Well Name: SAN ISIDRO 16	Well Location: T20N / R3W / SEC 16 / SENE / 36.729516 / -107.763184	County or Parish/State: SANDOVAL / NM
Well Number: 8	Type of Well: OIL WELL	Allottee or Tribe Name:
Lease Number: NMNM105185	Unit or CA Name: SAN ISIDRO MANCOS	Unit or CA Number: NMNM119111
US Well Number: 3004321014	Well Status: Oil Well Shut In	Operator: FINLEY RESOURCES INCORPORATED

Type of Action: Plug and Abandonment

Attachment to Notice of Intention to Plug and Abandon

Well: San Isidro 16 #8 (API#30-043-21014)

Finley Resources Inc. P&A Procedure
San Isidro 16-8 NMNM 105185 API# 30 043 21014
2207' FNL & 1000 FEL Sec 16 T20N R3W NMPM
Sandoval County, NM.

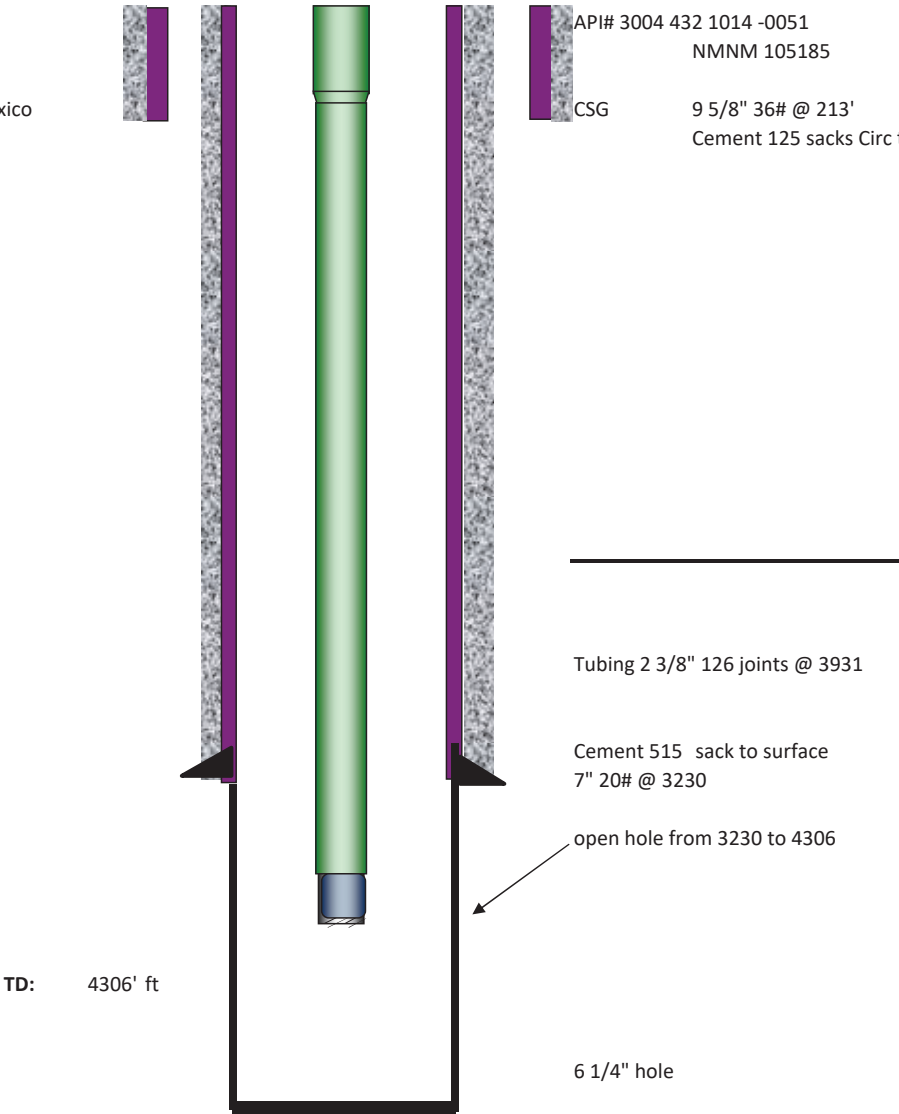
- a. Increase volume of cement pumped below the CICR to 180 sacks for plug #1 (Step 6) to cover BLM El Vado, Tocito Sandstone Lentils, and Gallup formation top picks.

- b. Adjust plug #2 (Step 10) to cover BLM Cliff House formation (Mesa Verde Group top) top pick @ 2220'. (Estimated minimum 26 class C cement covering 2120' to 2270')

- c. Add plug to cover BLM La Ventana formation top pick @ 1850'. (Estimated minimum 26sxs class C cement covering 1750' to 1900')
 - d. Add plug to cover BLM Lower Chacra formation top pick @ 1490'. (Estimated minimum 26sxs class C cement covering 1390' to 1540')

- e. Adjust plug #3 (Step 11) to cover BLM Picture Cliff formation top pick @ 762'. (Estimated minimum 26sxs class C cement covering 662' to 812')
 - f. Add plug to cover BLM Fruitland and Ojo Alamo formation picks @ 510' and 390', respectively. (Estimated minimum 46sxs class C cement covering 290' to 560')

- g. Adjust Surface Shoe and Surface Plugs (Steps 12 and 13) to cover from 263' to surface. (Estimated minimum 45 sxs)
